Ecology's Comments on "Draft Tank Closure and Waste Management Environmental Impact Statement"

Suzanne Dahl Tank Waste Treatment Section Manager
Nuclear Waste Program

Peak Groundwater Results from Various Waste Forms and Secondary Waste

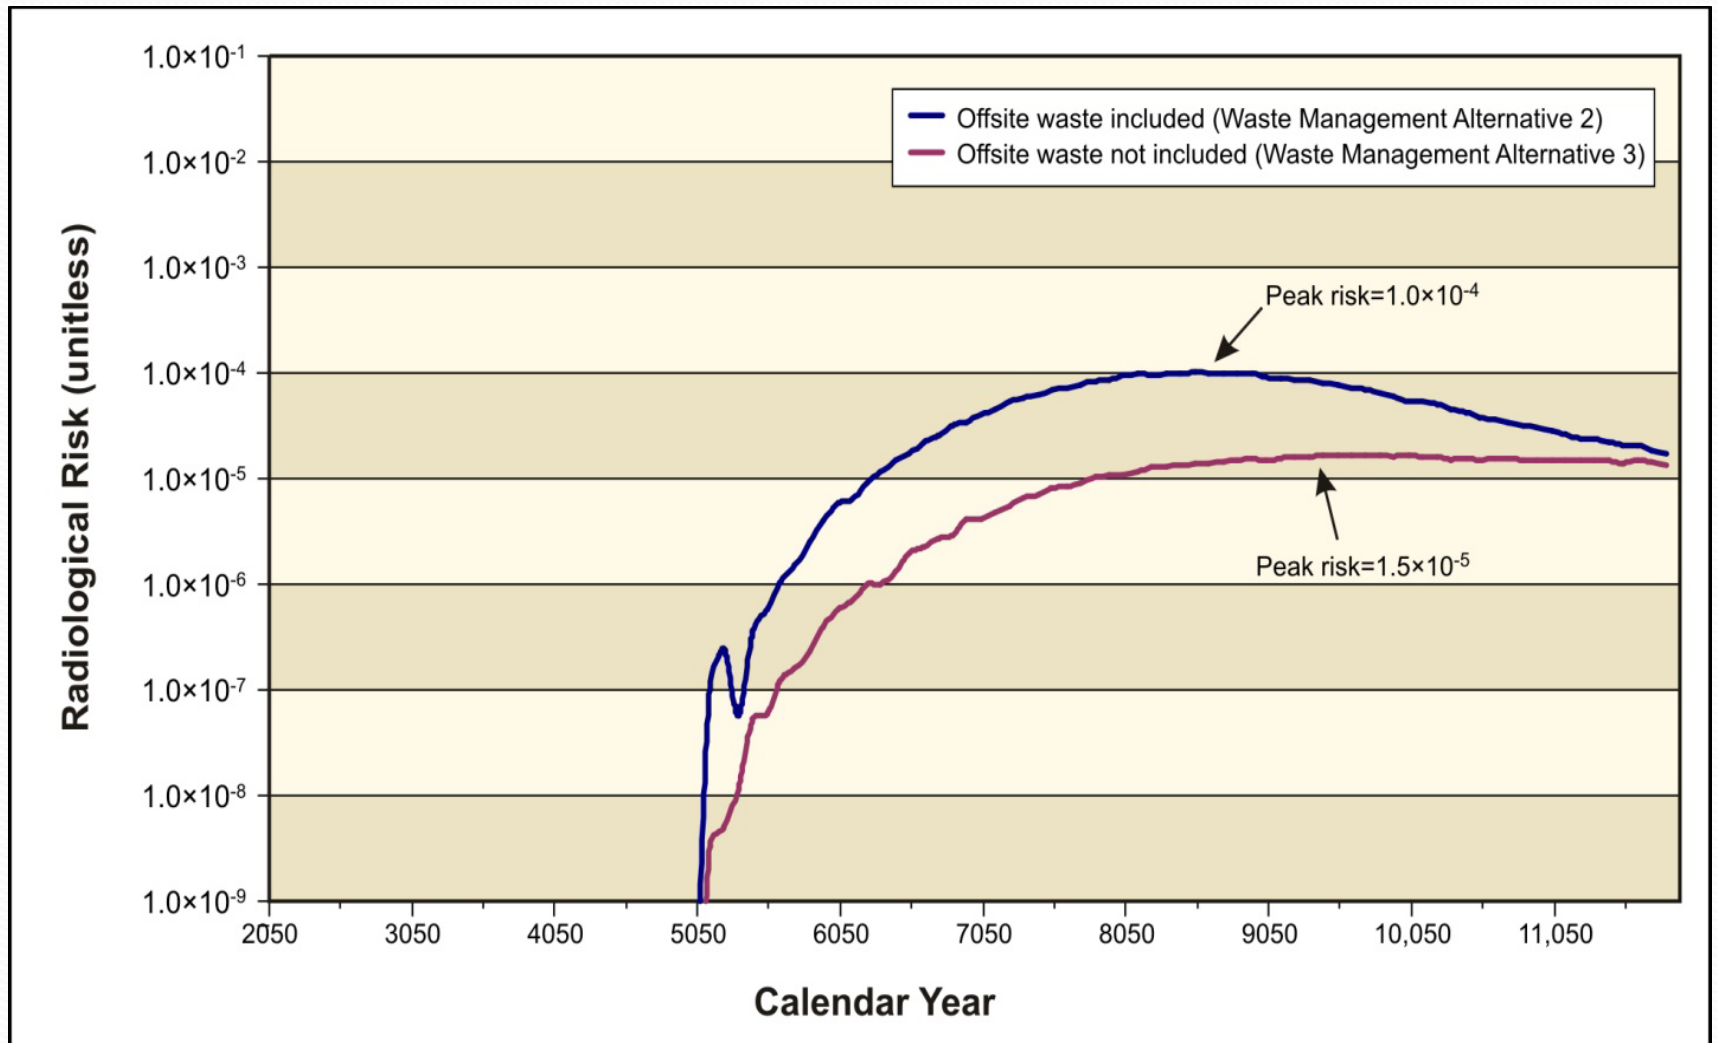
- For all glass options, most of the impacts come from secondary waste. Secondary waste causes significant groundwater impacts and needs robust mitigation to get below levels of concern.

- Results are without offsite waste inventory and impacts
- On Vitrification option most (all) contamination comes from secondary waste

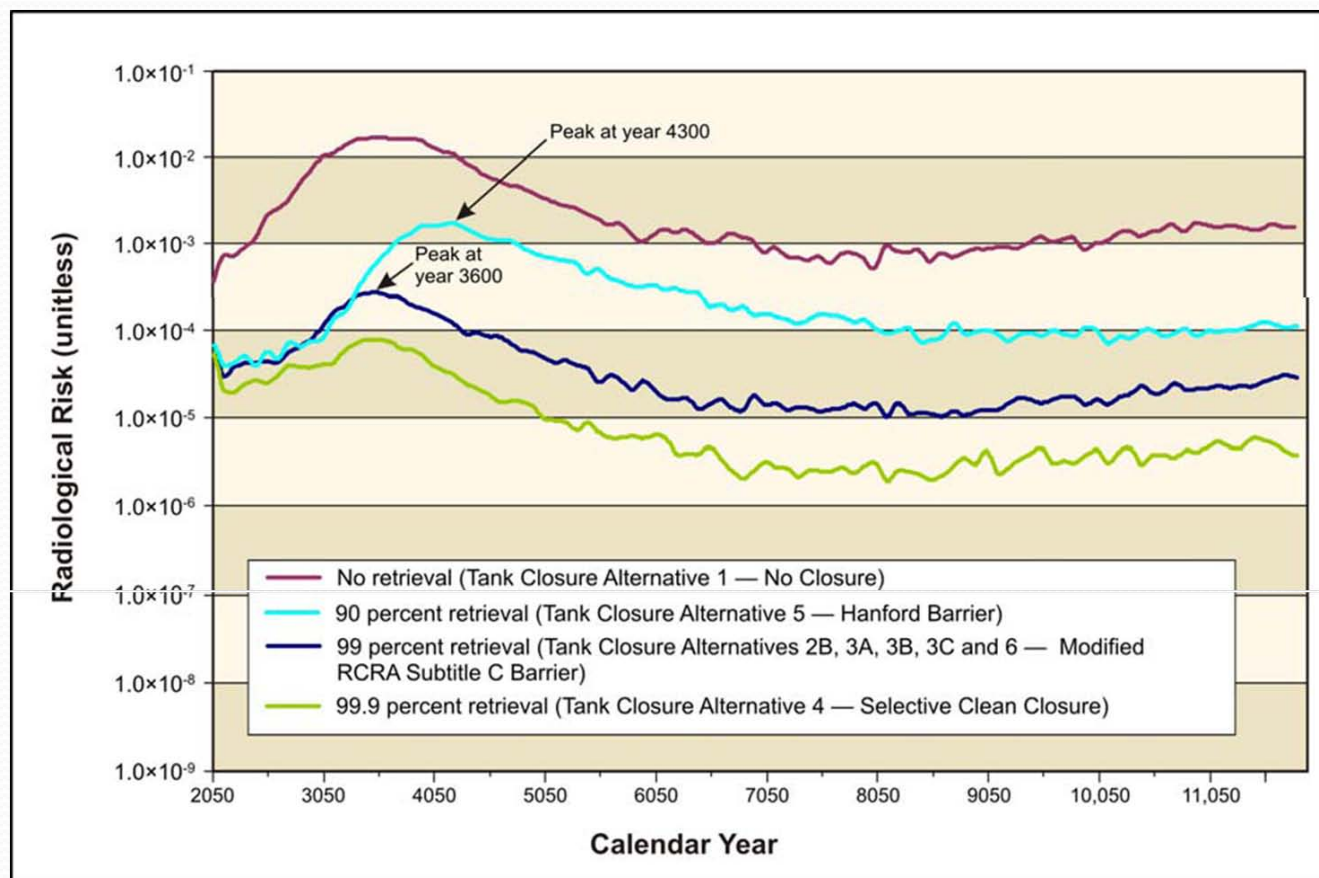
- Offsite waste disposal causes unacceptable environmental impacts.

- Integrated Disposal Facility in 200 East is a better choice when considering impact to groundwater.

- About 17 pCi/l of Iodine and 1500 pCi/l of Technetium from offsite waste in East location

Figure S-17. Lifetime Radiological Risk for the Drinking-Water Well User at the Core Zone Boundary due to Past Leaks at Single-Shell Tank Farms

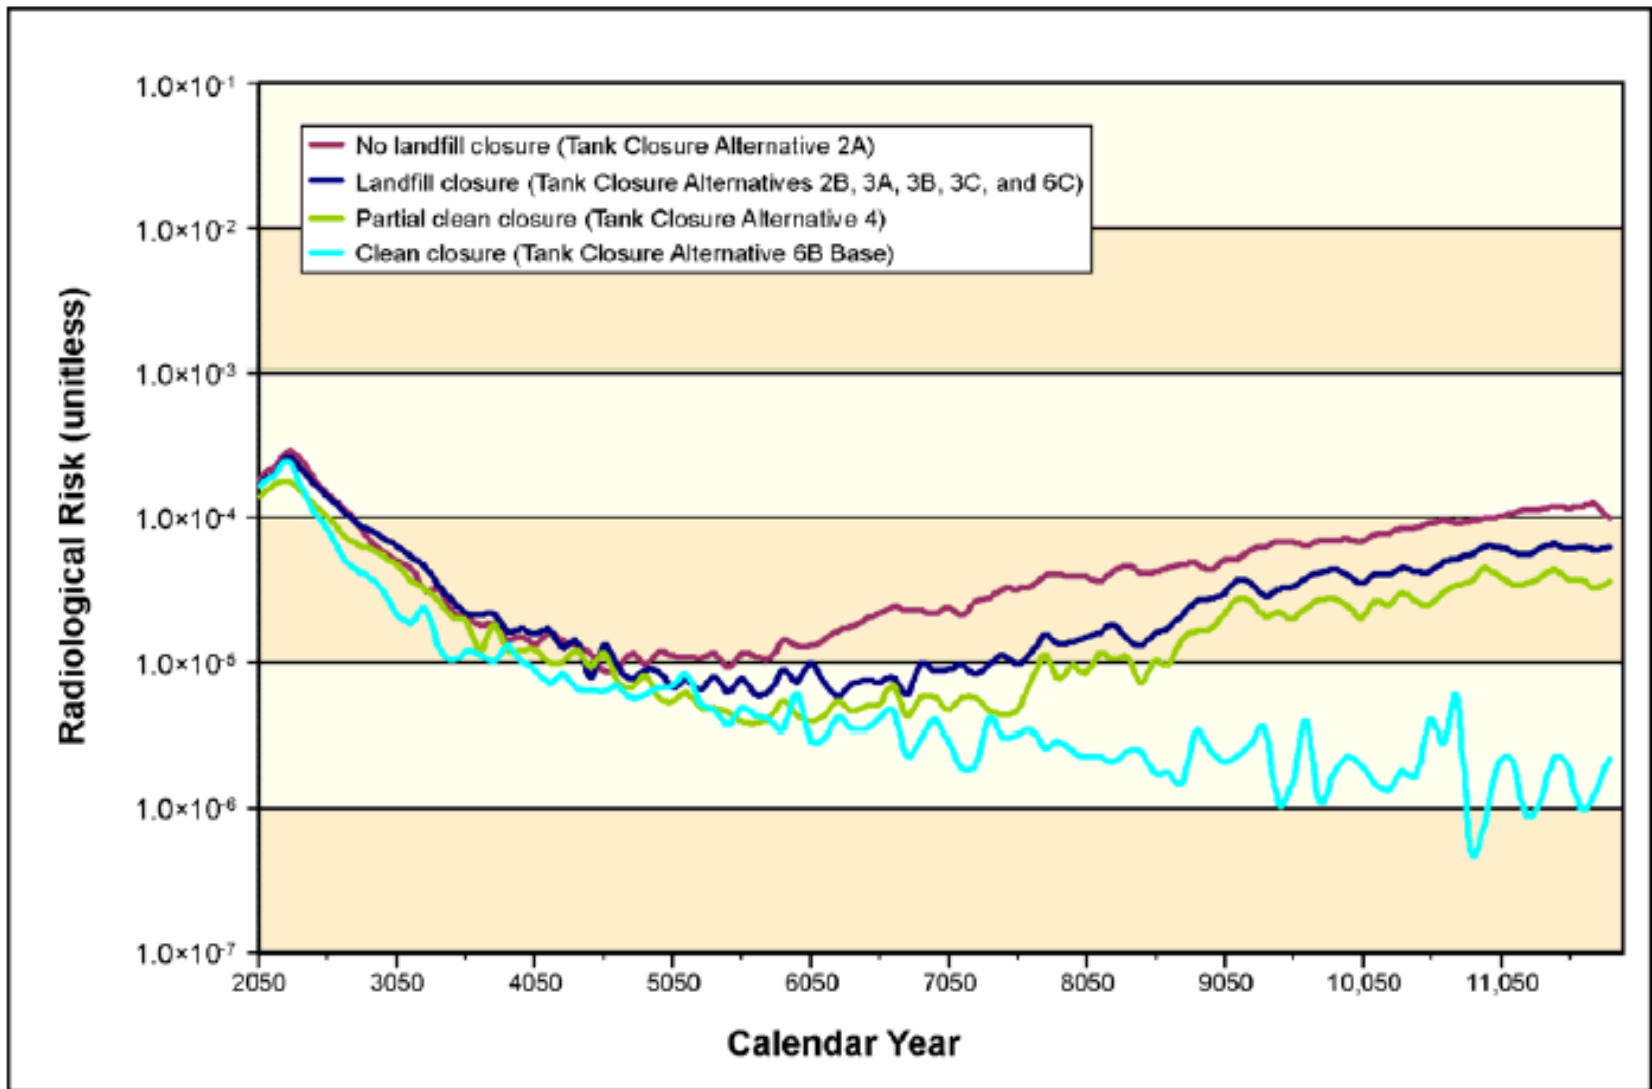
- Draft EIS indicates that greater than 99% retrieval makes a difference.
